The Natasha Project- Proposed New Residential Construction Project (DPD #3017563)

SEATTLE DESIGN REVIEW

October 14, 2014 | Early Design Guidance Meeting 2

Response to the Priorities & Board Recommendations section (page 4 of 17) of the Early Design Guidance 1 meeting report:

A-1 Respond to the Physical Environment

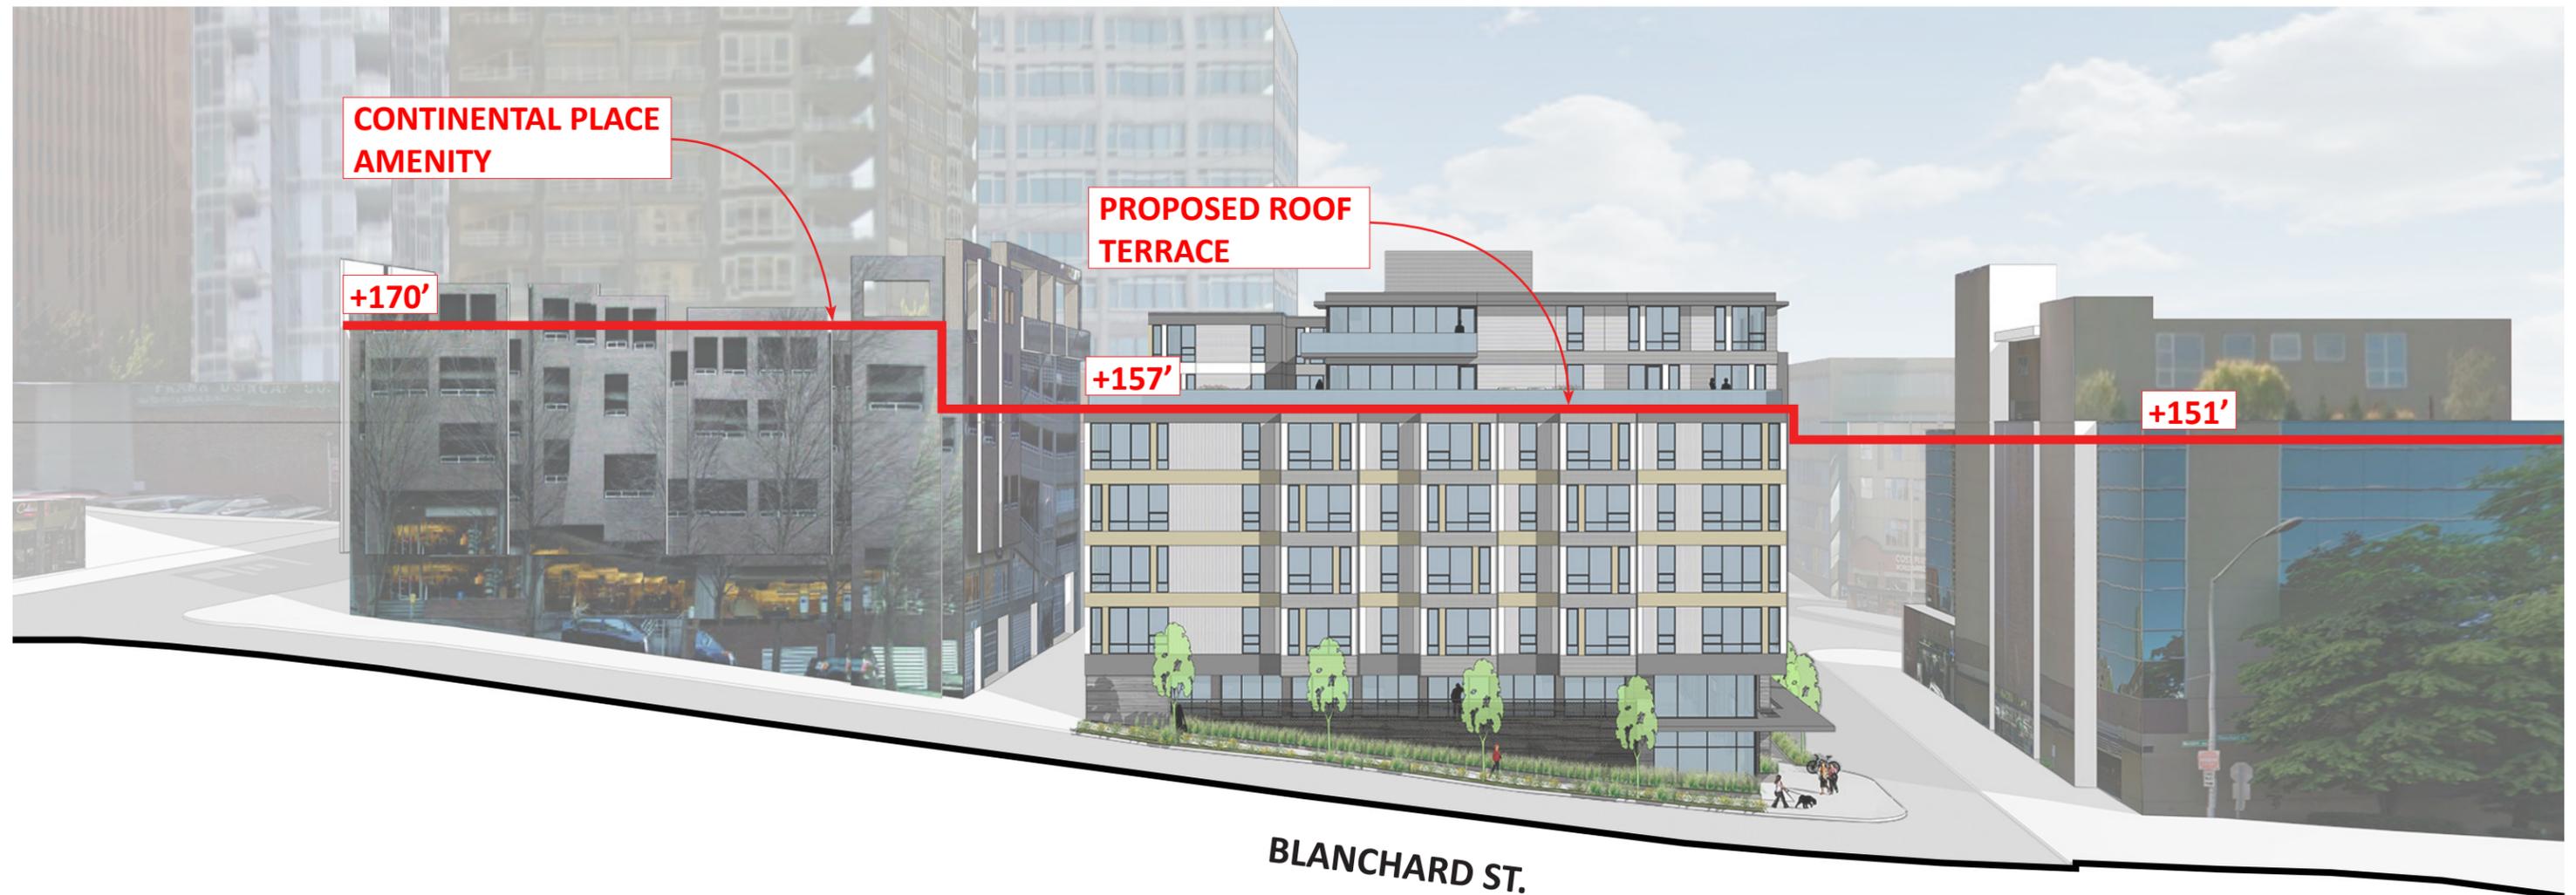
“Consider the location of nearby existing outdoors deck/roof amenity areas when located similar uses on the roof.” (p4 2.c.)

The massing of the proposed design comfortably addresses the surrounding urban context by stepping down with along Blanchard St.

A-1 Respond to the Physical Environment

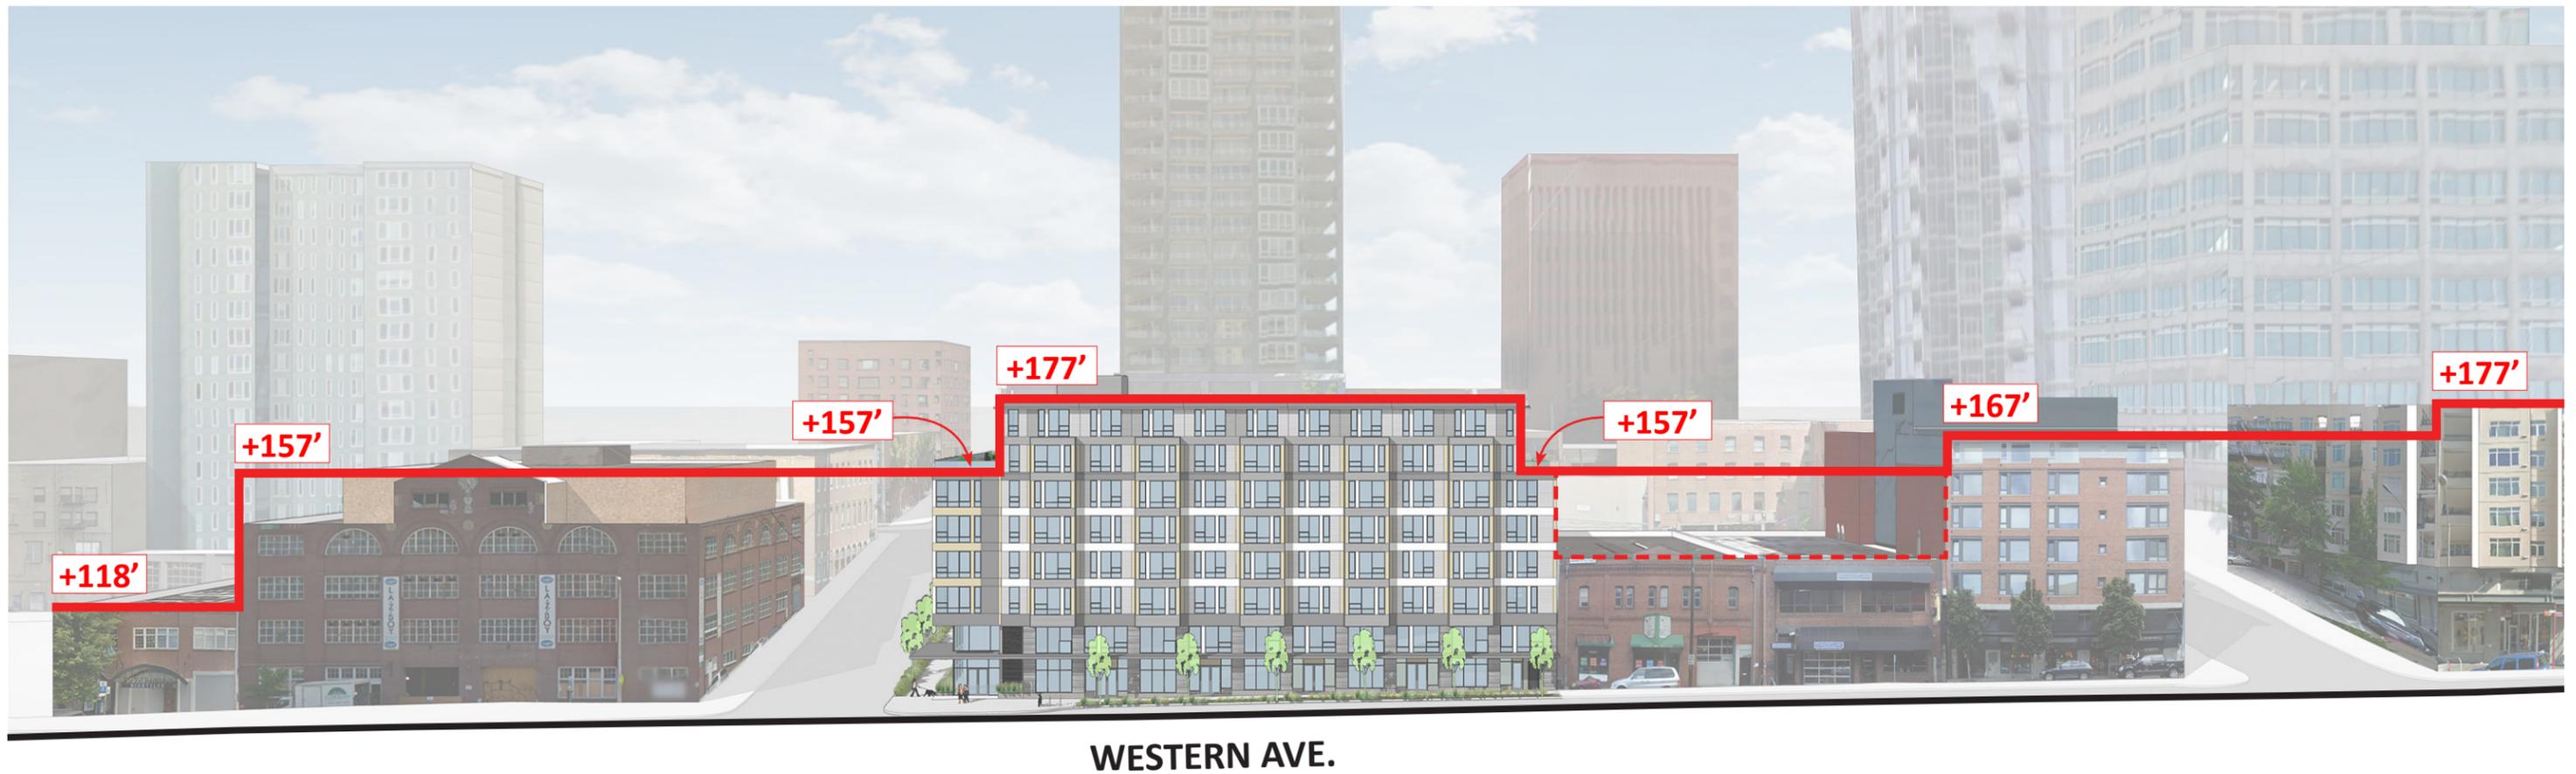
“...shifting of the setbacks to be more sympathetic to the surrounding structures.” (p4 2.a.)

“Consider notching the corners at the upper levels.” (p4 1.a.)

“The board noted they preferred the scale of the mixed use development at the corner of Lenora St. and Western Ave...study its massing for cues on how to diminish the overall height, bulk and scale of this project.” (p4 1.c.)

The massing of the proposed design complements the surrounding urban context along Western Ave.

E-1 Minimize Curb Cuts

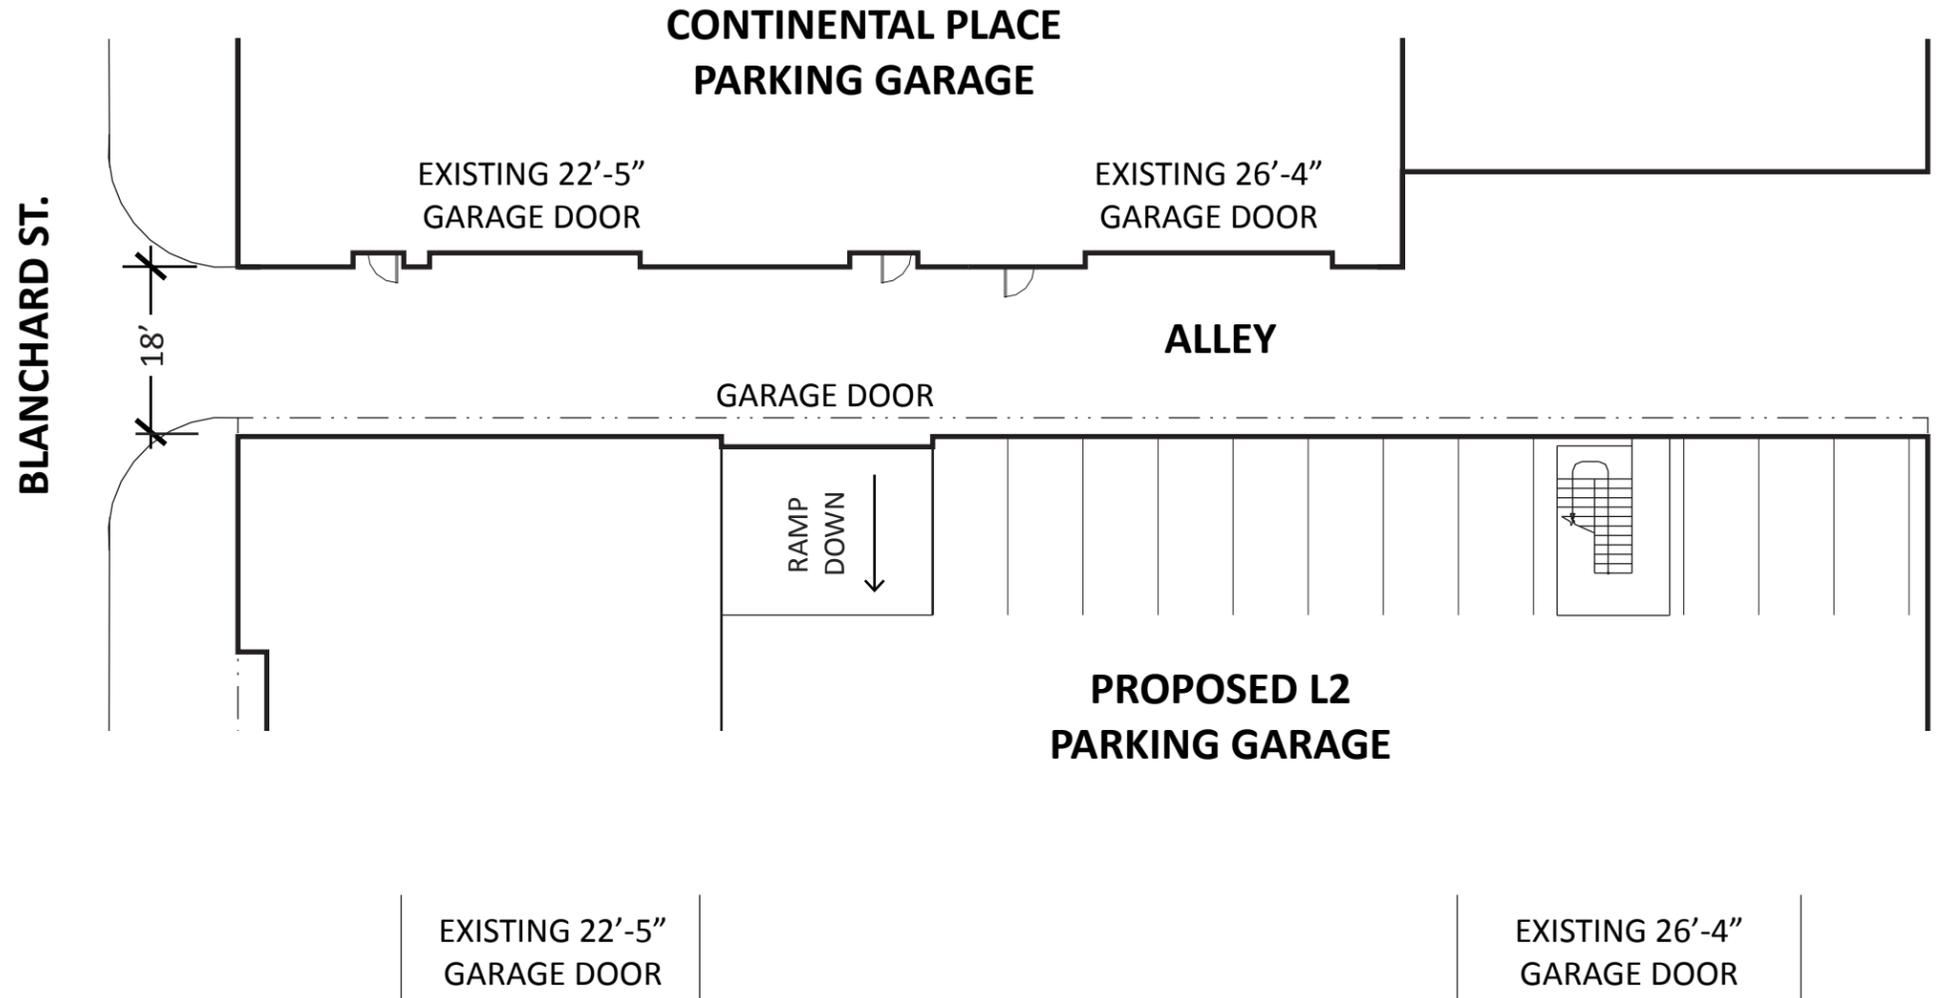
“Study the relationship of the proposed garage entry in the alley to the existing entries of the development to the east.” (p4 2.d.)

All three existing curb cuts (two at Western Ave., one at Blanchard St.) will be eliminated and all vehicular access will be through the alley.

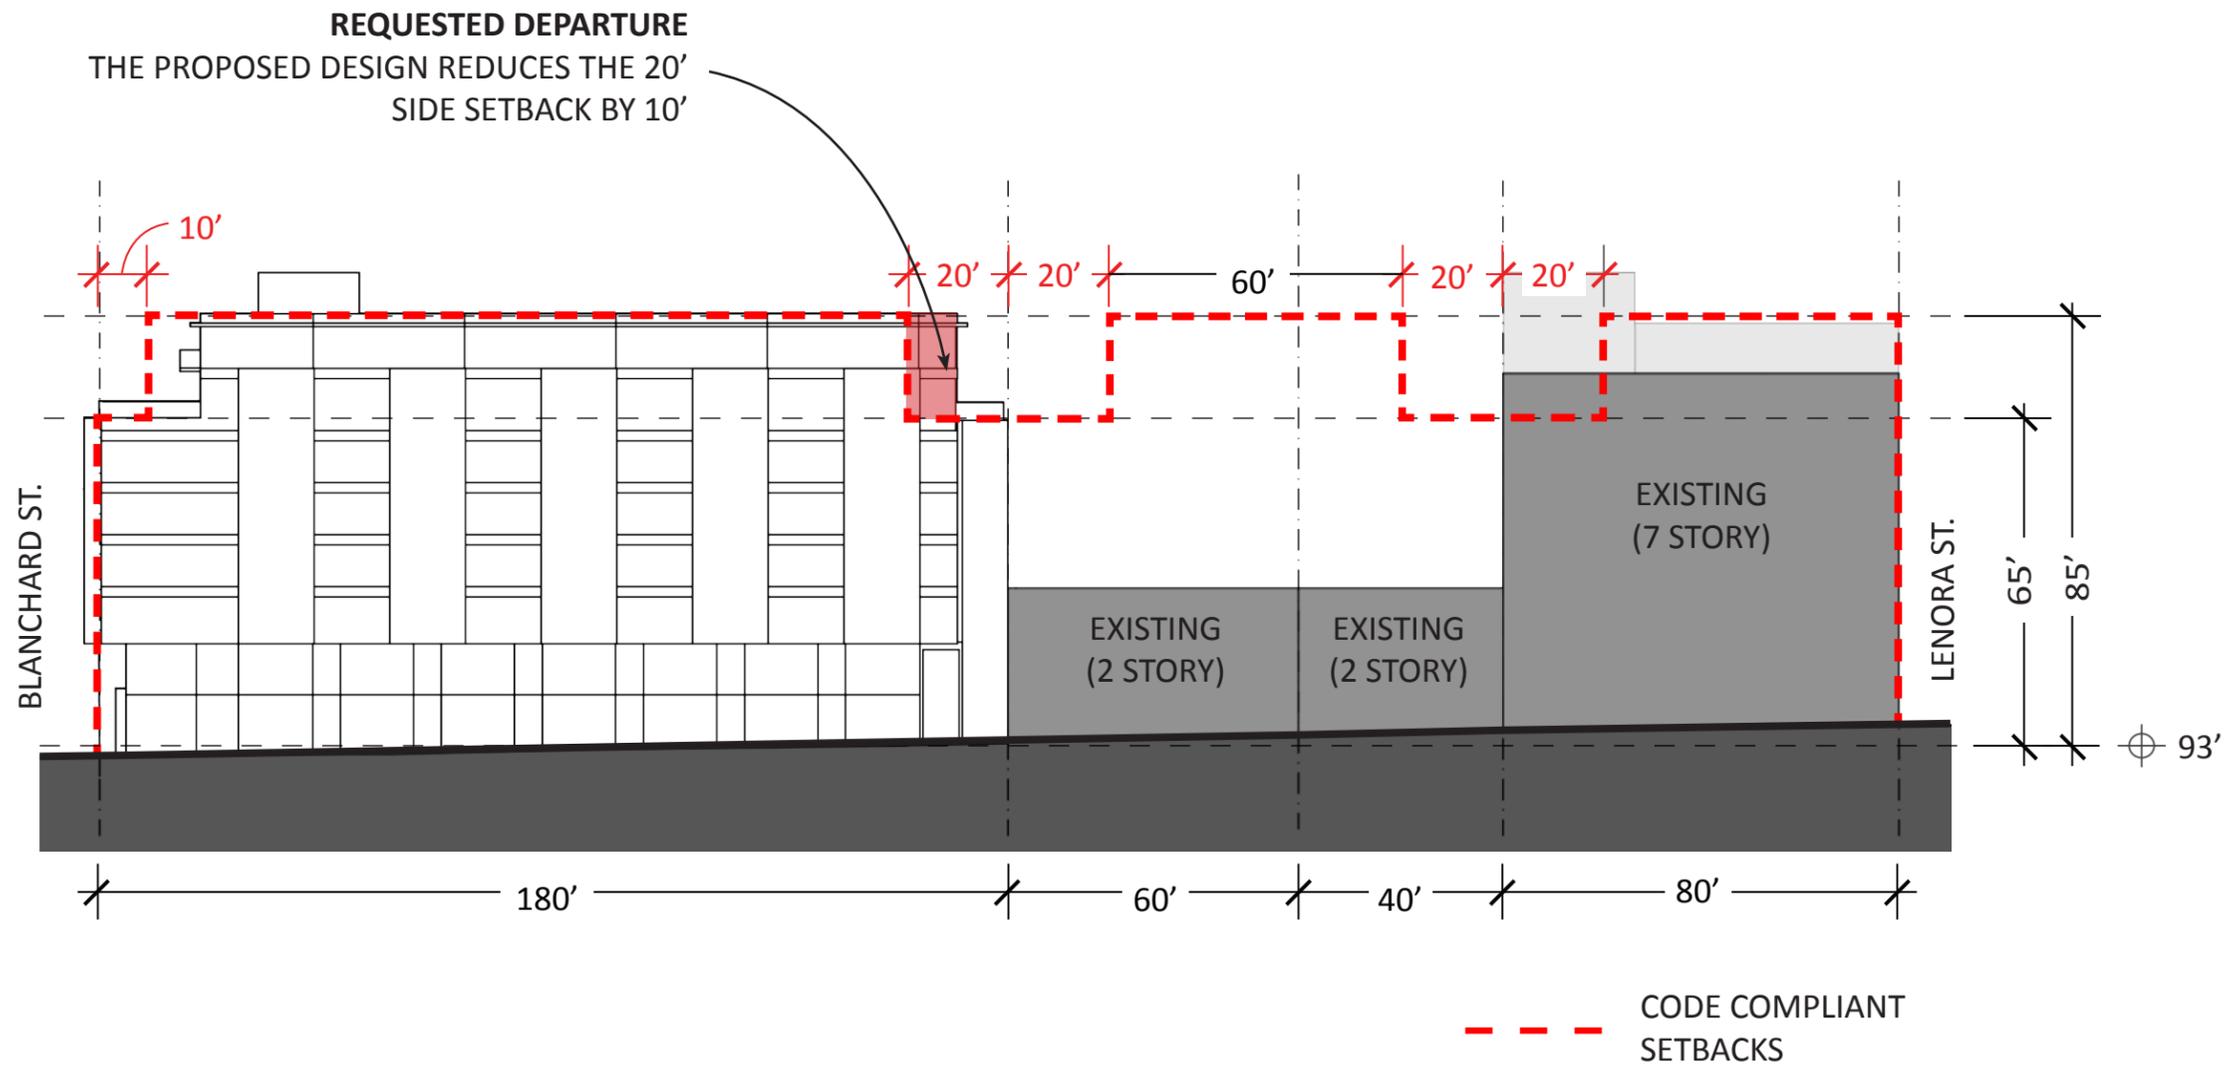
The Board indicated they needed to see how the massing gained by granting of the departure from the setback will impact nearby existing structures. Show where the massing area that would be gained by granting the departure would be subtracted from the overall massing. The applicant will need to show how granting the departure will make the project better meet the intent of the Design Guidelines.

In light of these two arguments, the proposed design requests a departure from the 20' side setback requirement to a 10' side setback. See p23-27 for more information regarding this departure.
